## **CALKINS-TROOST-RAINBOW-HAGGERTY STORM LINE REPLACEMENT ADDENDUM #1**

**Project:** Calkins-Troost-Rainbow-Haggerty Storm  
Line Replacement

**Prepared by:** Cole Riley, EIT  
Erik Ranger, PE  
i.e. Engineering, Inc  
809 SE Pine St.  
Roseburg, OR 97470

**Response date:** 03.23.2023

# C.8

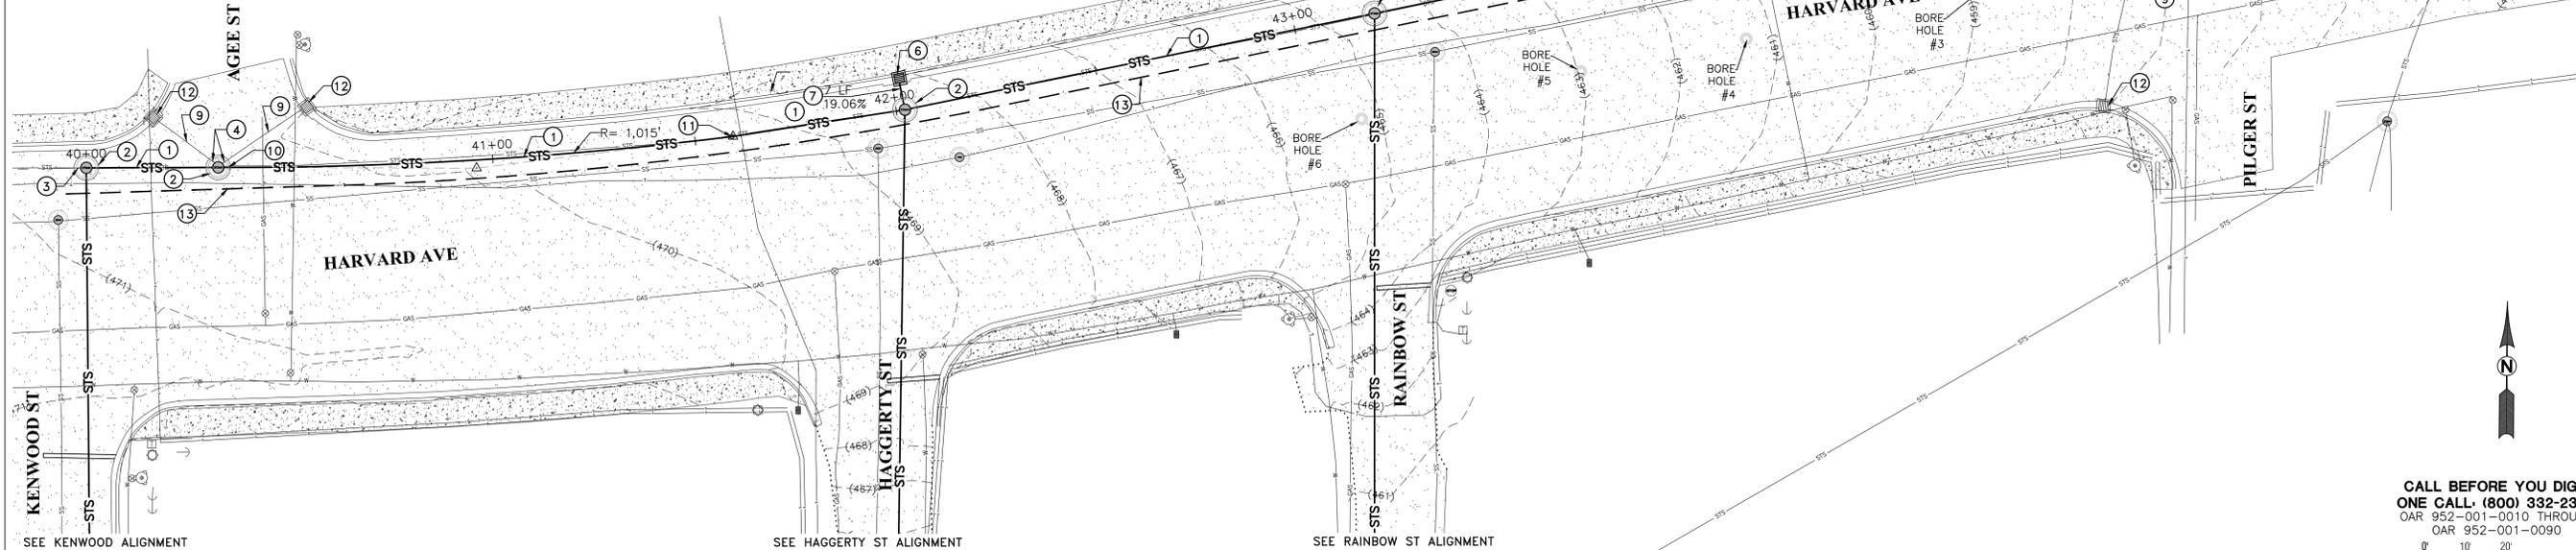
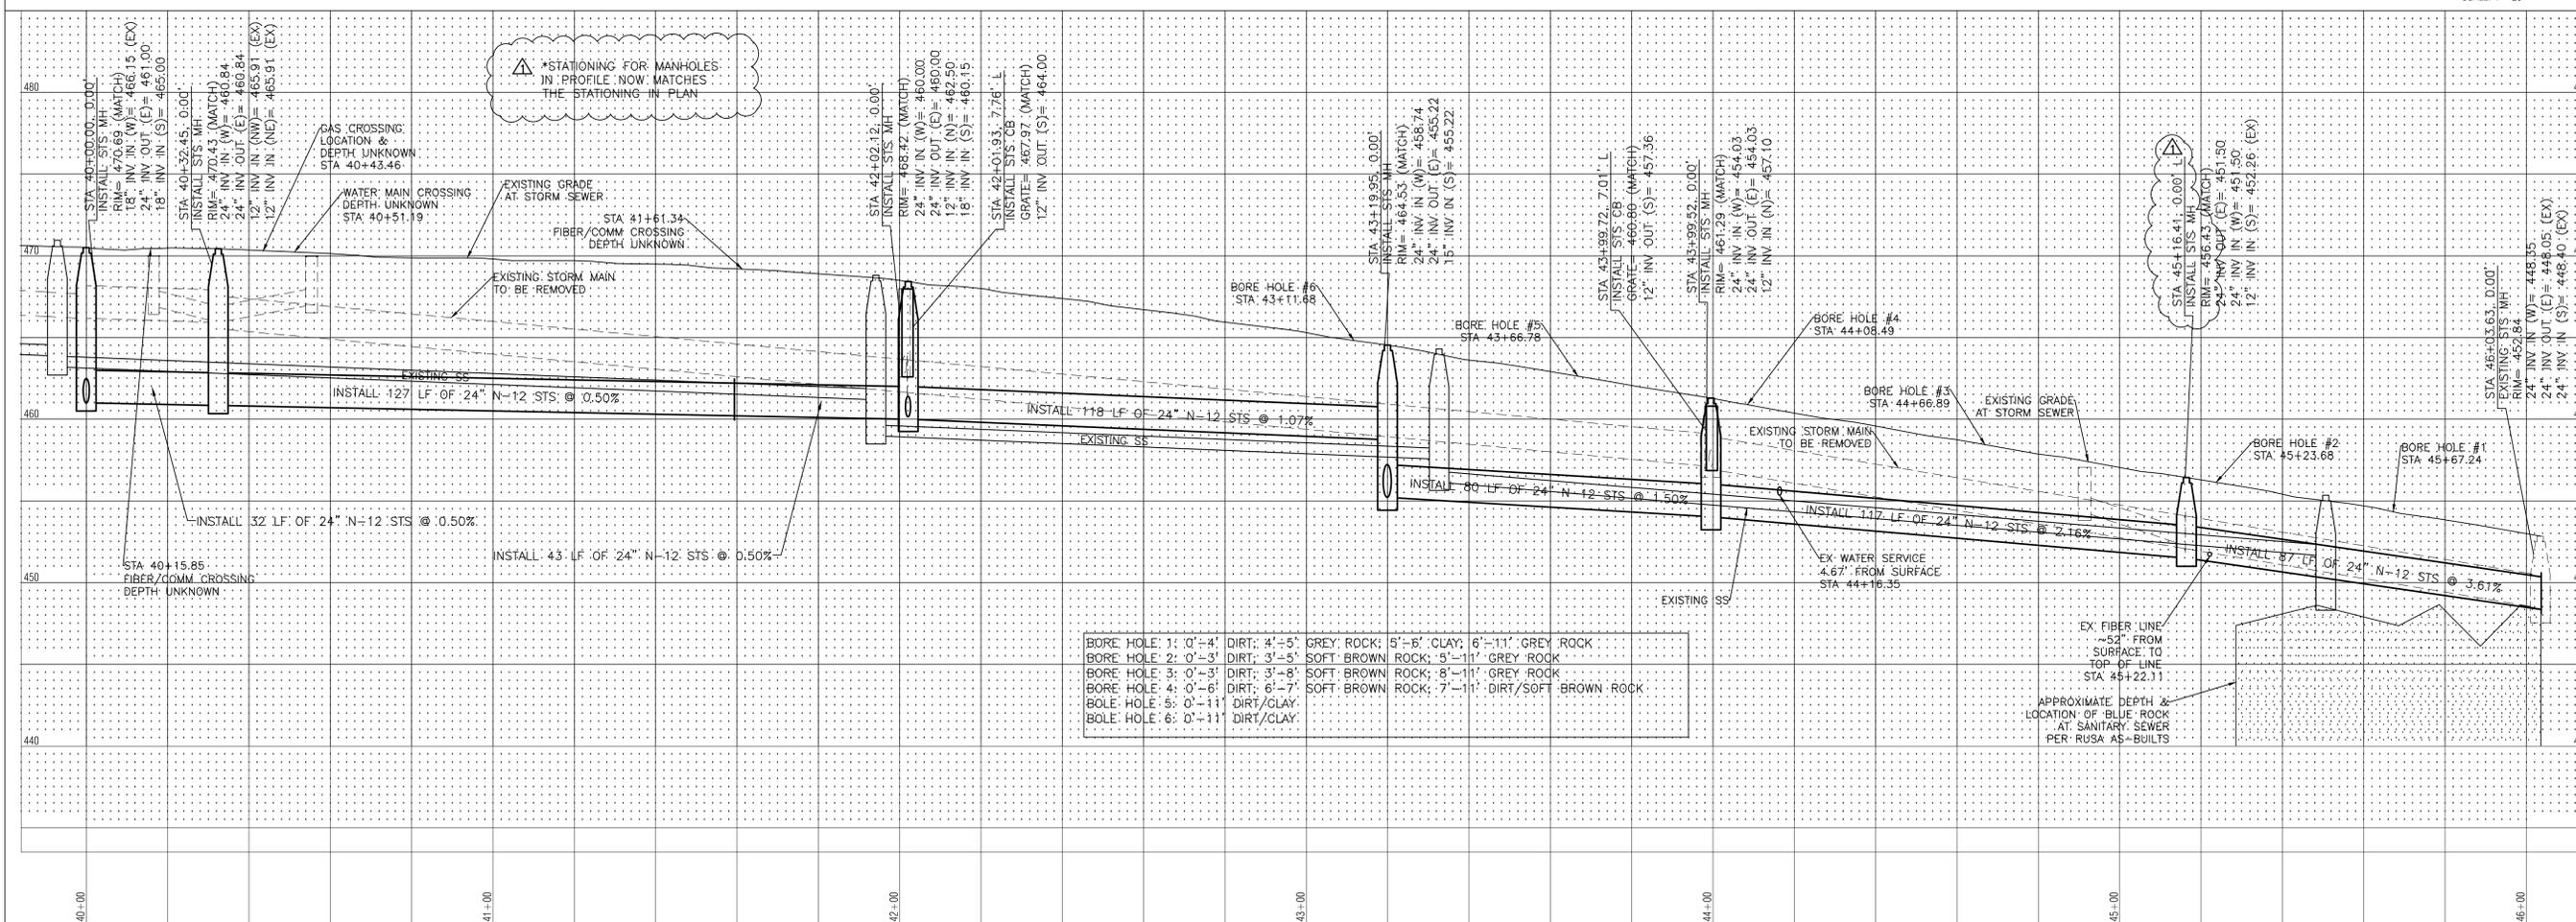
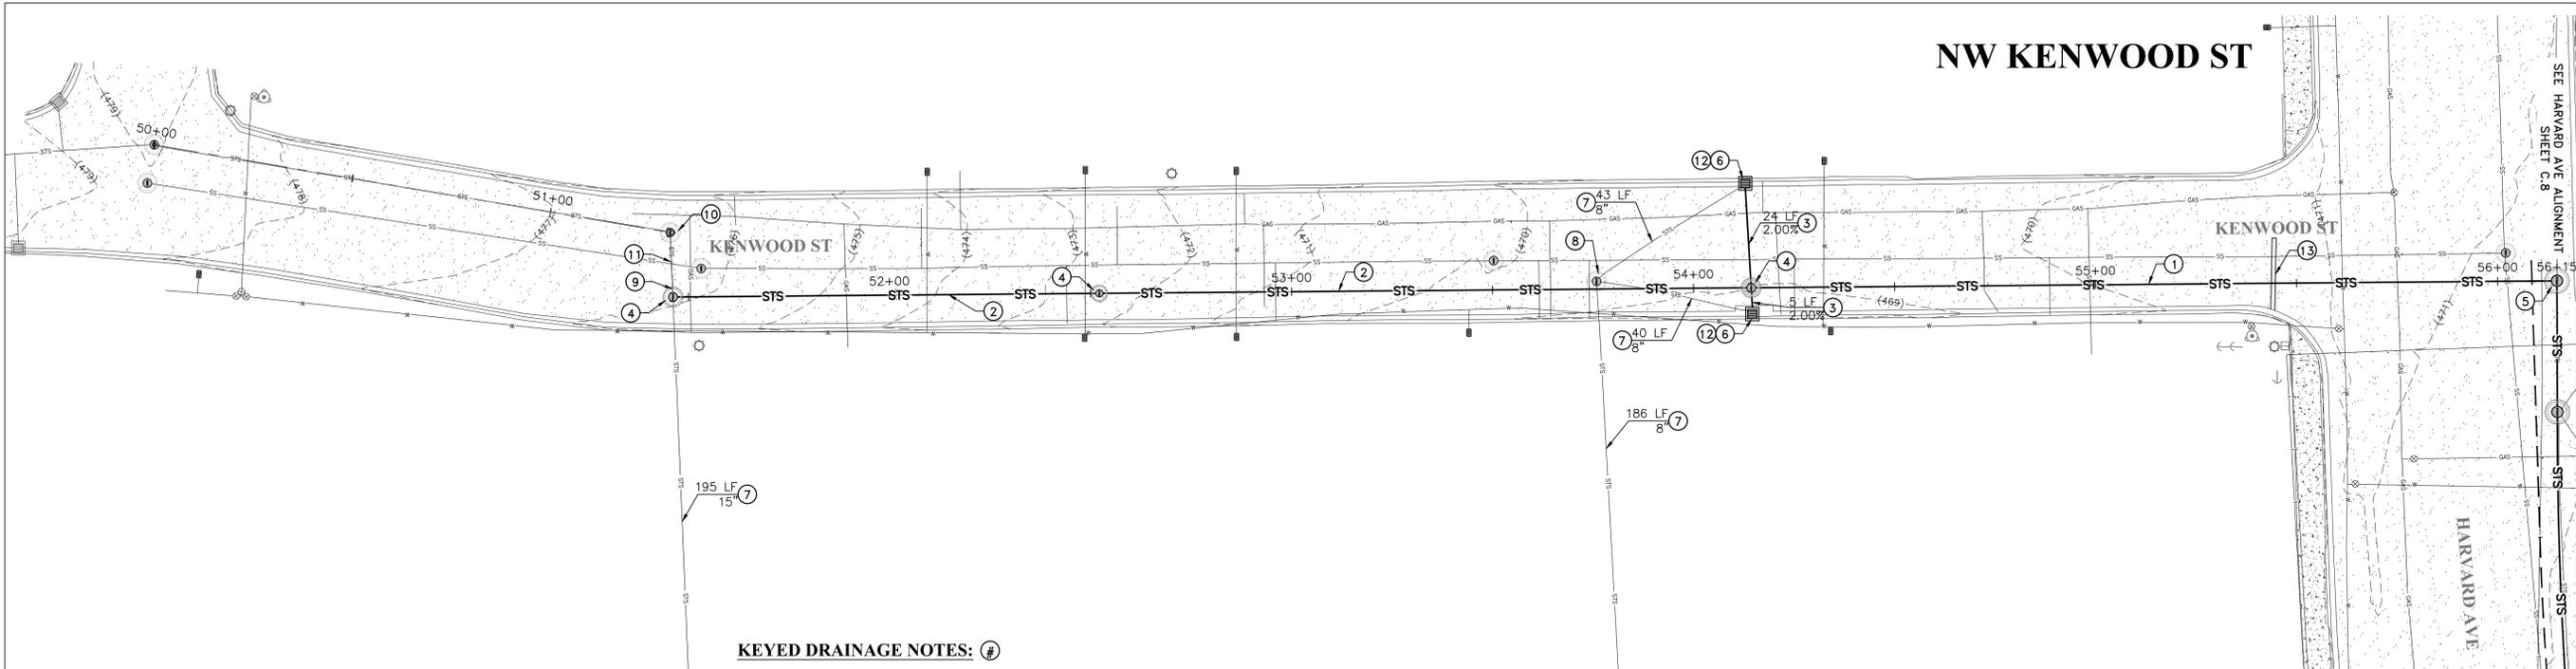
- b. On Sheet C.8, the stationing for manholes at STA 42+01.90, 43+99.30, 45+16.18, 46+13.41 were revised to match the stationing shown on the plan and profile. They were changed to the following, respectively: STA 42+02.12, 43+99.52, 45+16.41, 46+03.63.

- c. On Sheet C.8, the rim elevation for the manhole at STA 45+16.41 (originally STA 45+16.18 prior to addendum) was revised to match the existing finished grade of 456.43

HARVARD AVE  
 ROSEBURG, OR  
**KENWOOD ST ALIGNMENT**  
 HORIZ. 1"=20' VERT. 1"=5'  
 FEBRUARY 20, 2023  
 ISSUE FOR BID  
 CHK: EDR

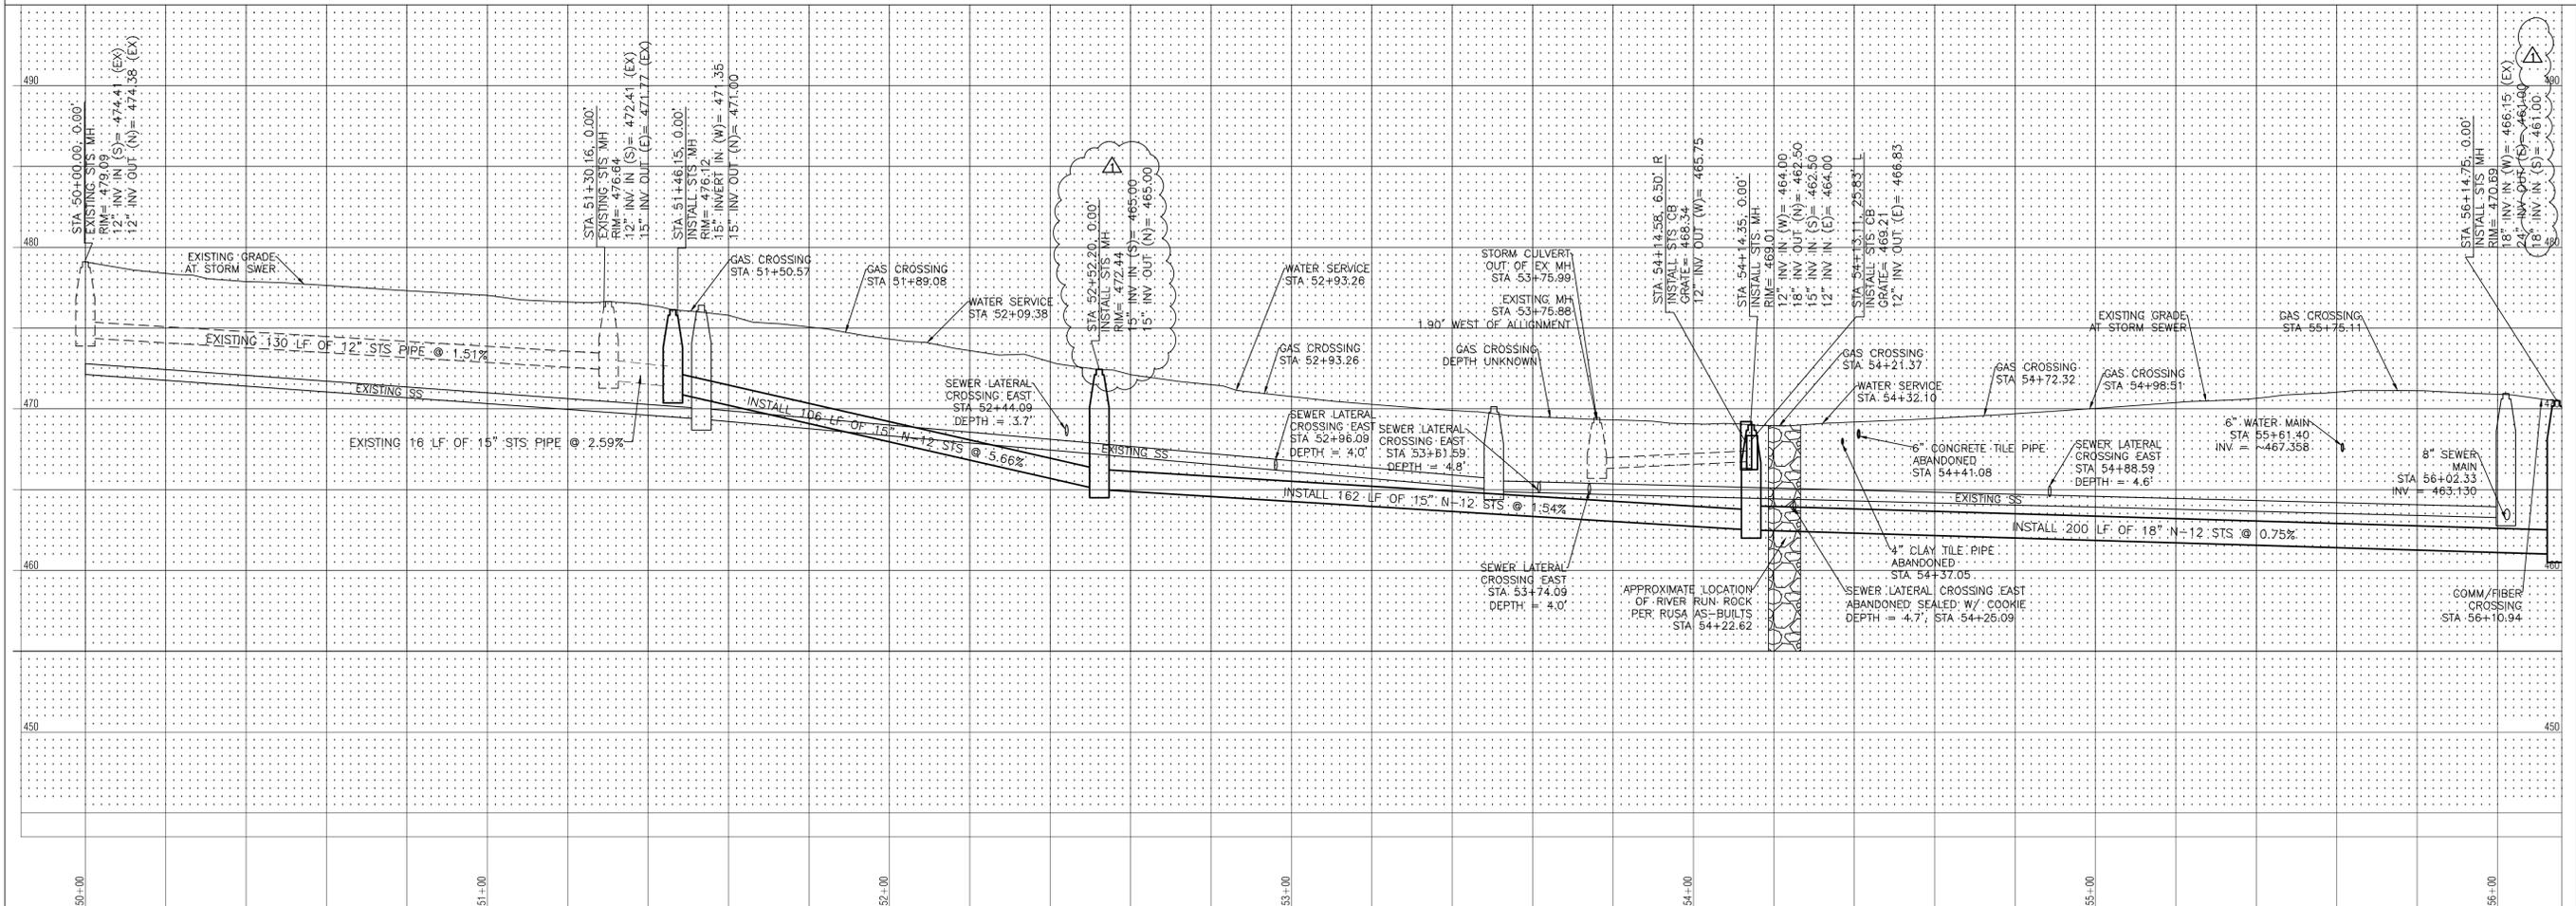
- d. On Sheet C.9, the labels for the manhole at STA 52+52.20 were added to the profile, which include rim and invert elevations.
- e. On Sheet C.9, the label for the manhole at STA 56+14.75 were revised so that "18-IN INVERT IN (S)" to the manhole is now 461.00, was previously 465.00.

# C.10

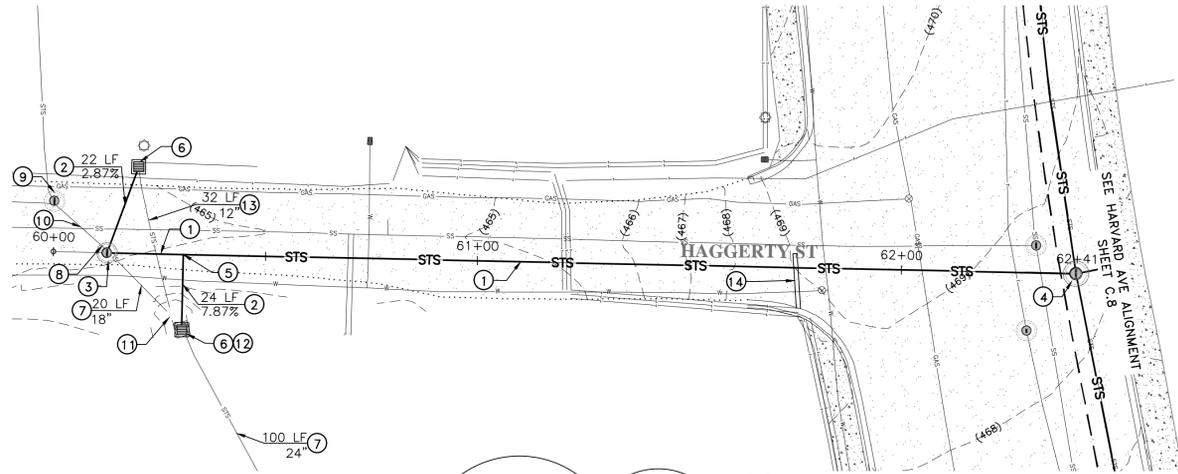
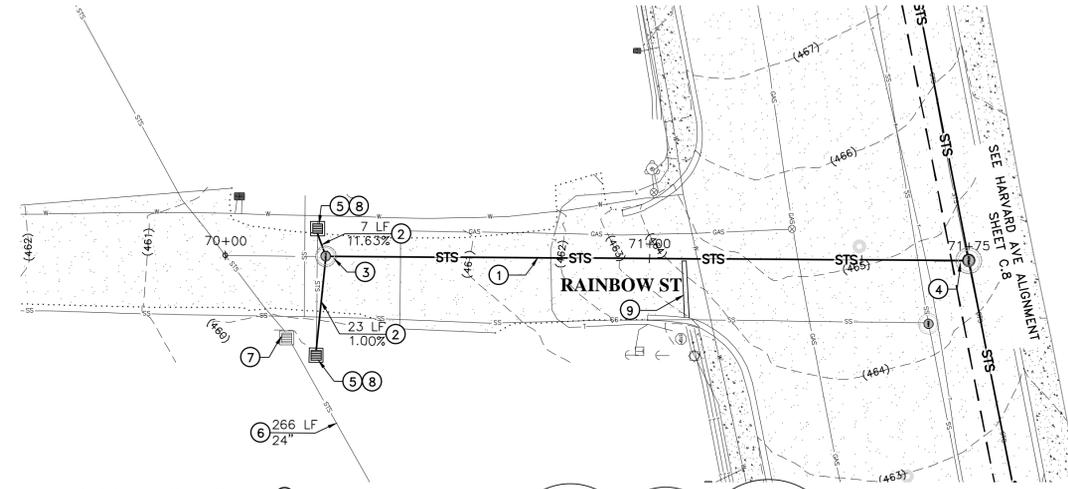
- f. On Sheet C.10, the 12" invert out elevation for the Type D inlet at STA 60+19.69 was changed from 462.80 to 462.00 to allow for greater clearance between the drainage pipe and structure's inlet grate.

- g. On Sheet C.4, note 24 has been added for removal of existing catch basin. This is paid under BI #5.
- h. On Sheets C.6, C.7, and C.10, the notes that begins "ABANDON EXISTING STS PIPE IN PLACE, ....." has been revised to remove the language "GREATER THAN 12". All pipe sizes to be filled where shown.
